42 HONEYSUCKLE DRIVE COTTAGE CREEK PRECINCT NEWCASTLE

NEWCASTLE CITY COUNCIL
DEVELOPMENT APPLICATION

ARCHITECTURAL DESIGN STATEMENT

SUMMARY OF PROPOSED AMENDMENTS

6.1 DESIGN CHANGES SIXTH FLOOR

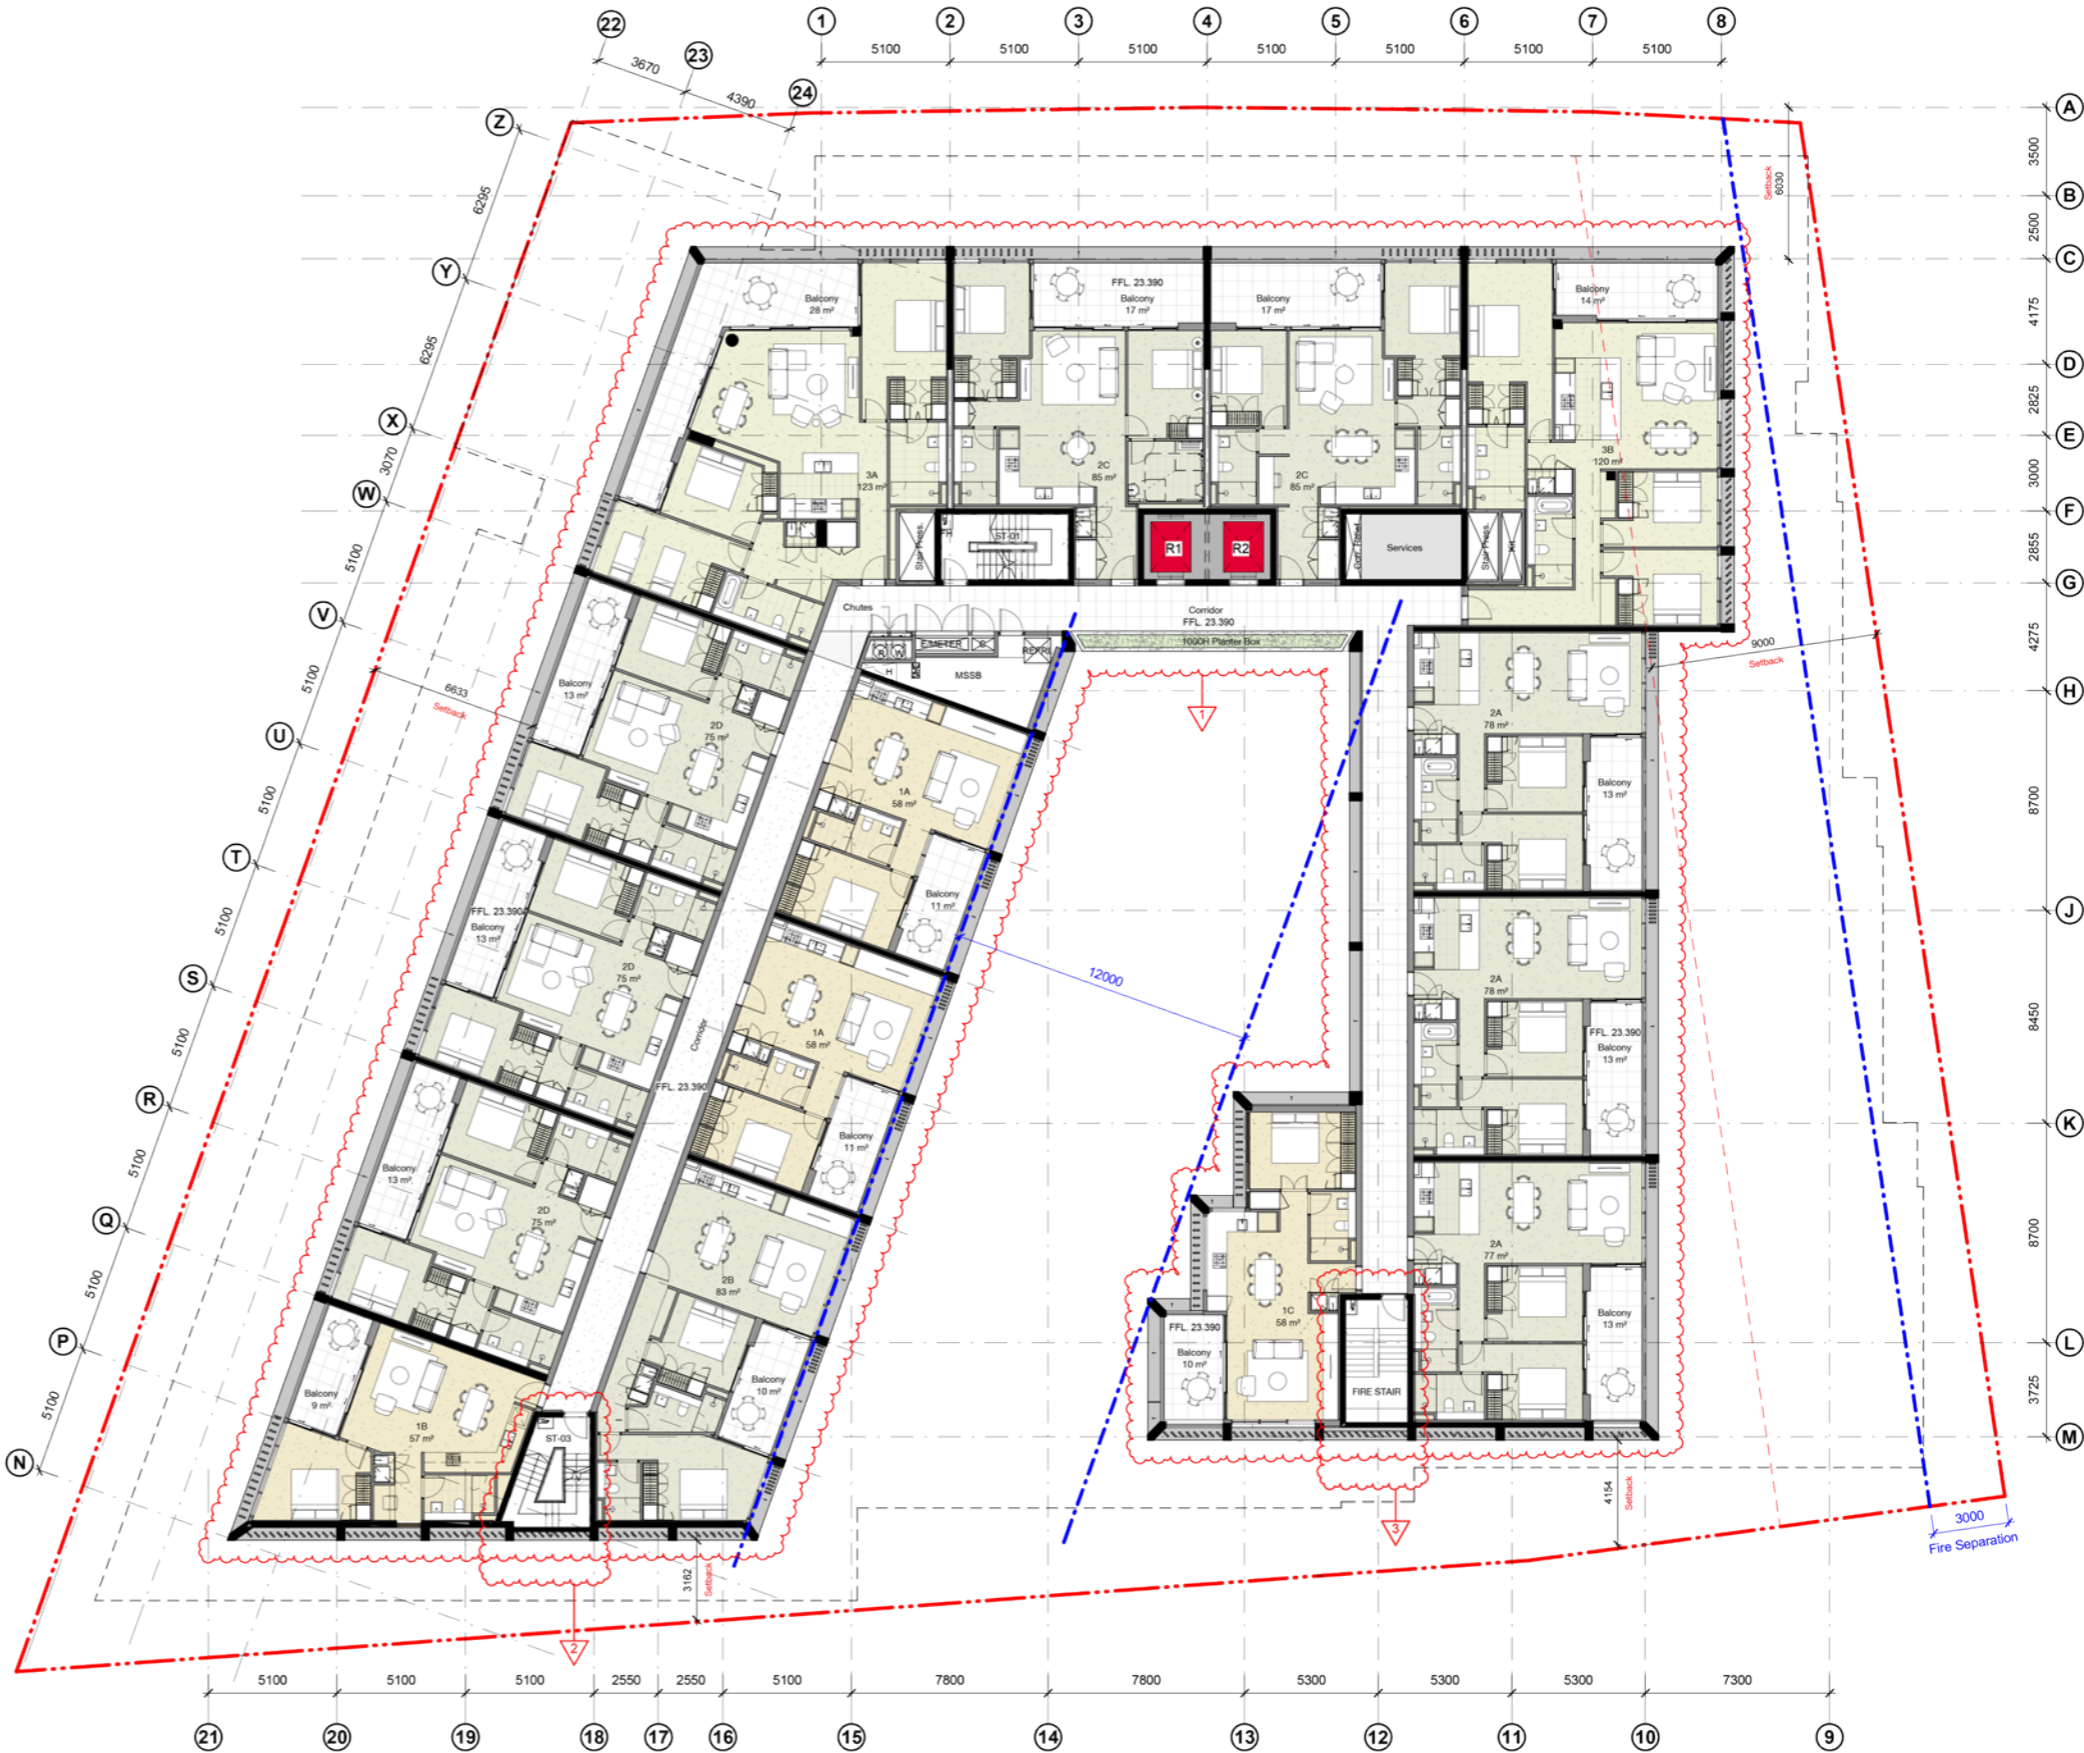
- 1 / Accommodation on Levels 05-08 amended from 52 residential apartments to 60 serviced apartments.
- Modifications to the south eastern building volume from Level 05 to 08 in response to the revised apartment typology
- Adjustments to the facade design from Level 05-08 in reponse to the revised apartment typologies. General materiality and facade components have been retained from the previously approved design.
- 2 / Adjustments to the location of the south western fire stair. To accommodate the revised serviced apartment floorplate, the fire stair shifts to the west by one hotel bay. Facade treatment from Ground to Level 04 are adjusted to suit.
- 3 / Adjustments to the location of the south eastern fire stair. To accommodate the revised serviced apartment floorplate, the fire stair shifts to the east. Facade treatment from Ground to Level 05 Parking are adjusted to suit.

7.1 DESIGN CHANGES SEVENTH FLOOR

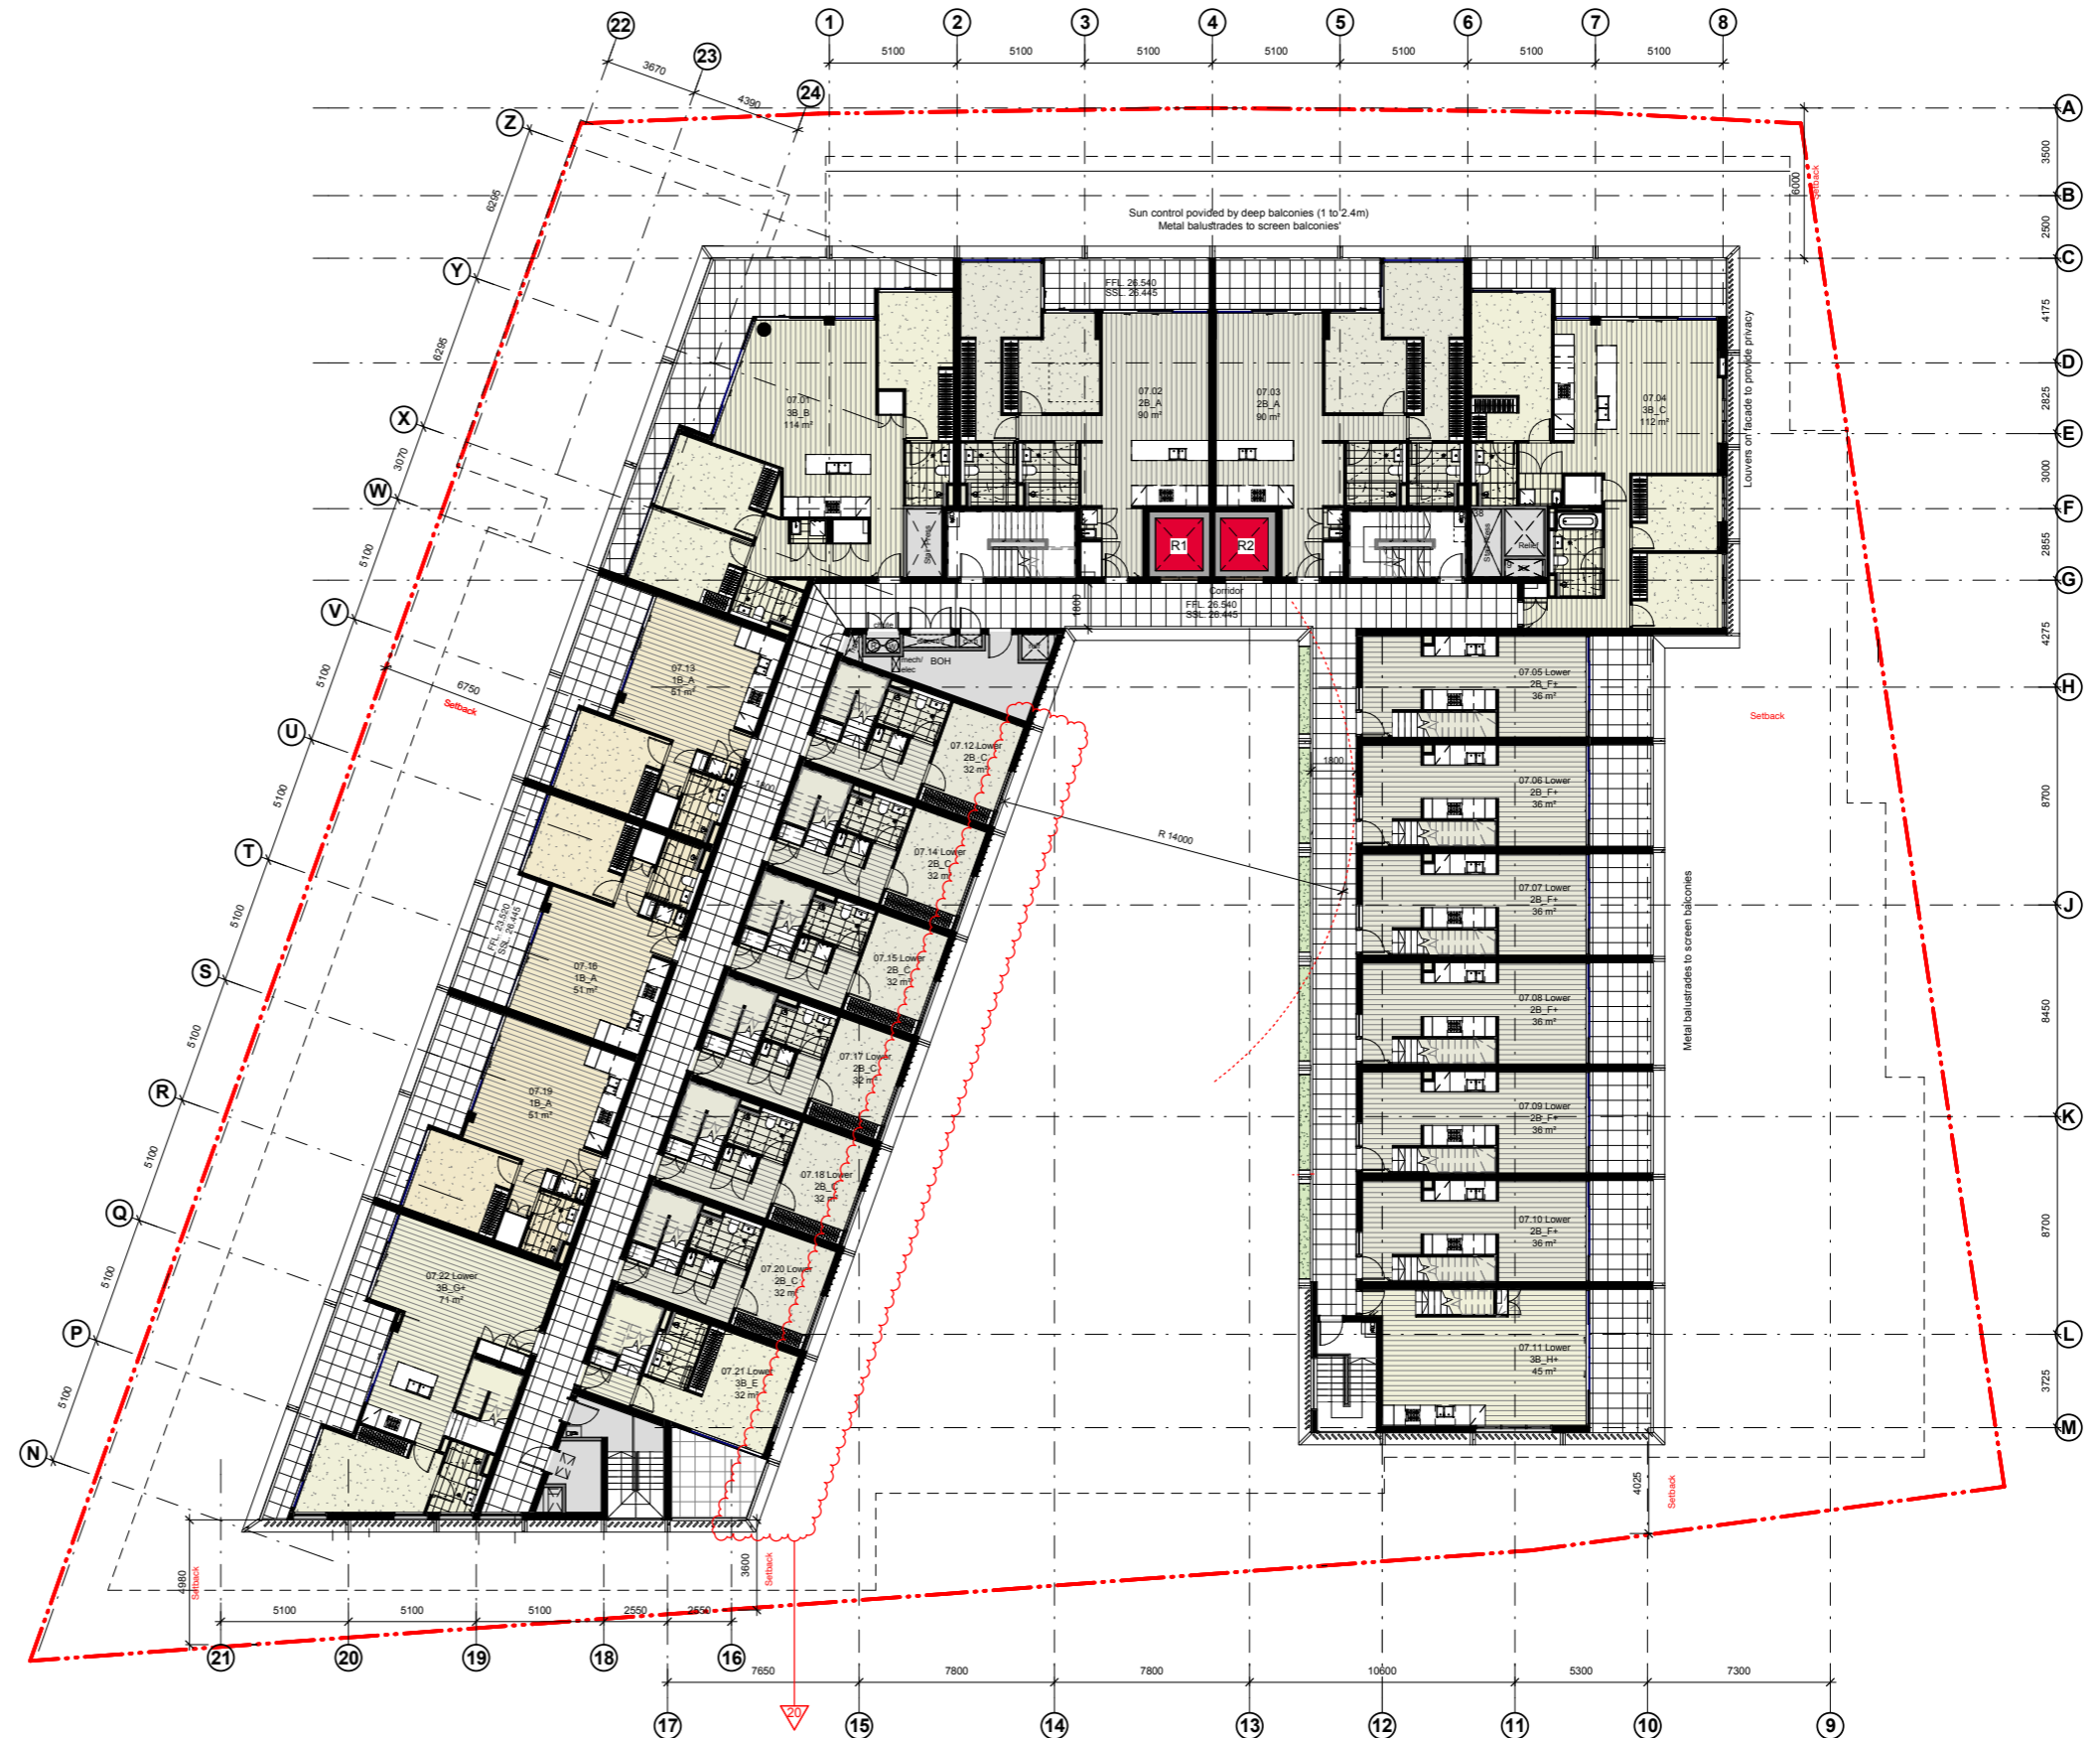
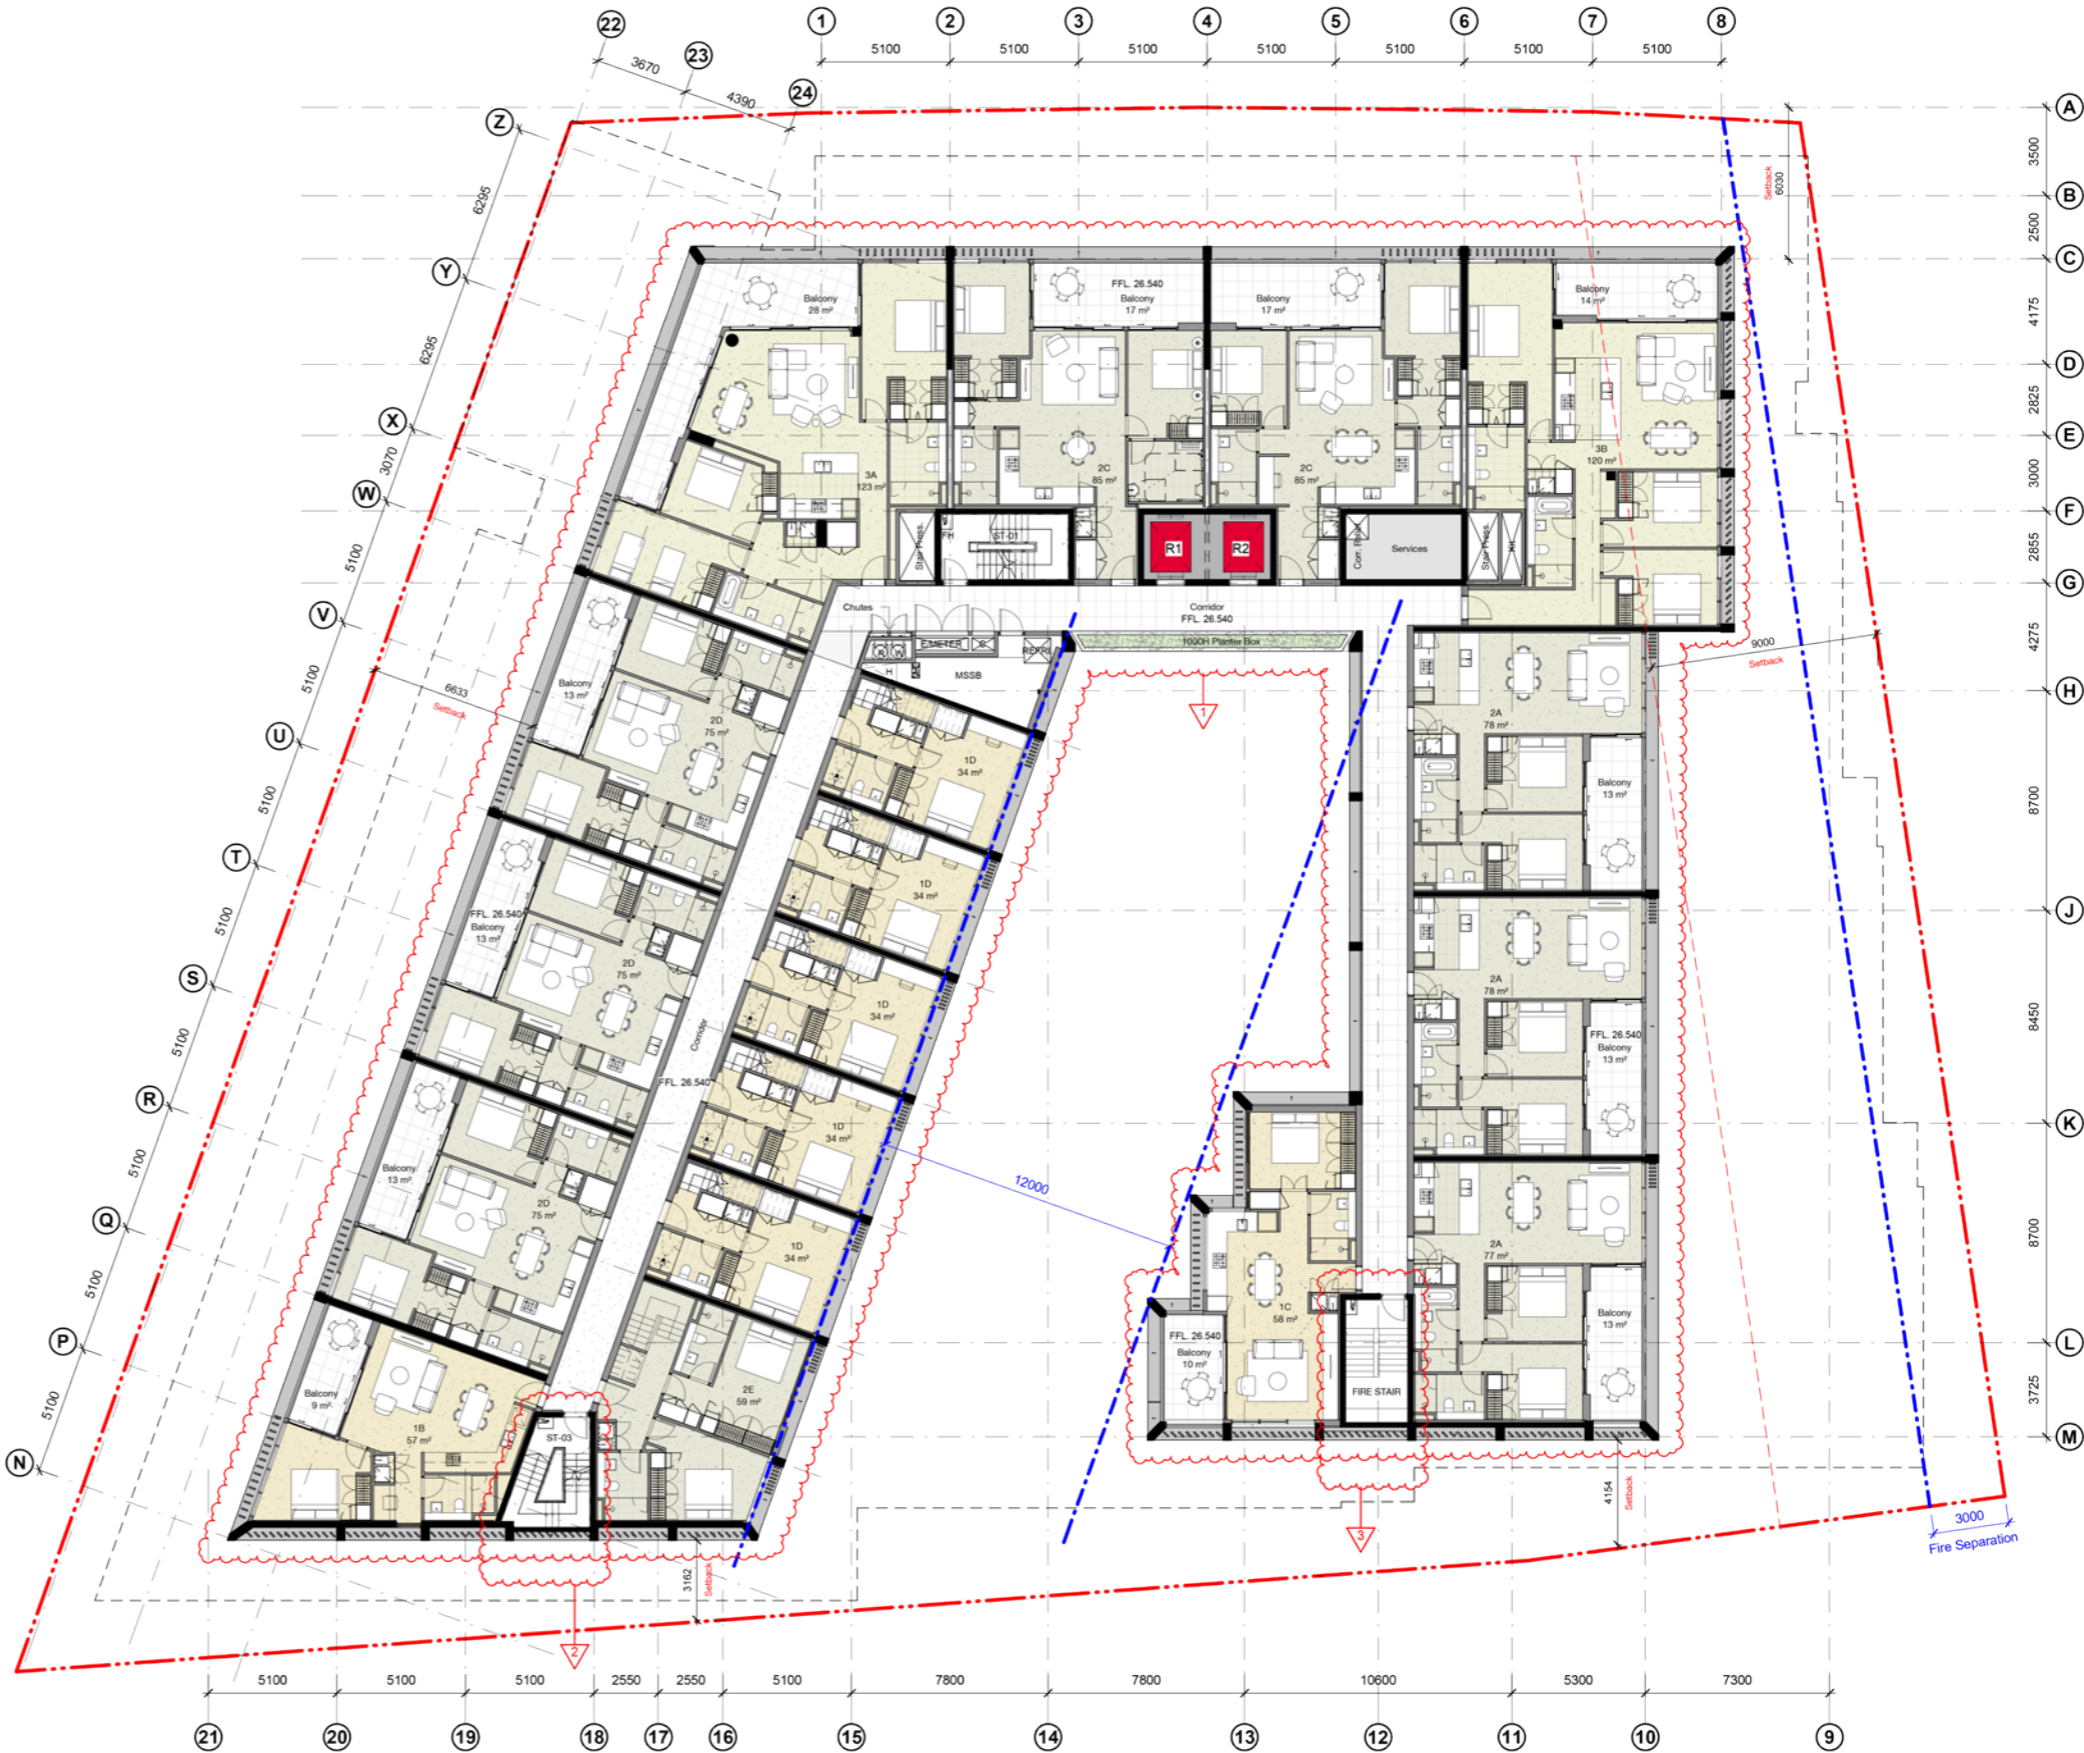
- 1 / Accommodation on Levels 05-08 amended from 52 residential apartments to 60 serviced apartments.
- Modifications to the south eastern building volume from Level 05 to 08 in response to the revised apartment typology
- Adjustments to the facade design from Level 05-08 in reponse to the revised apartment typologies. General materiality and facade components have been retained from the previously approved design.
- 2 / Adjustments to the location of the south western fire stair. To accommodate the revised serviced apartment floorplate, the fire stair shifts to the west by one hotel bay. Facade treatment from Ground to Level 04 are adjusted to suit.
- 3 / Adjustments to the location of the south eastern fire stair. To accommodate the revised serviced apartment floorplate, the fire stair shifts to the east. Facade treatment from Ground to Level 05 Parking are adjusted to suit.
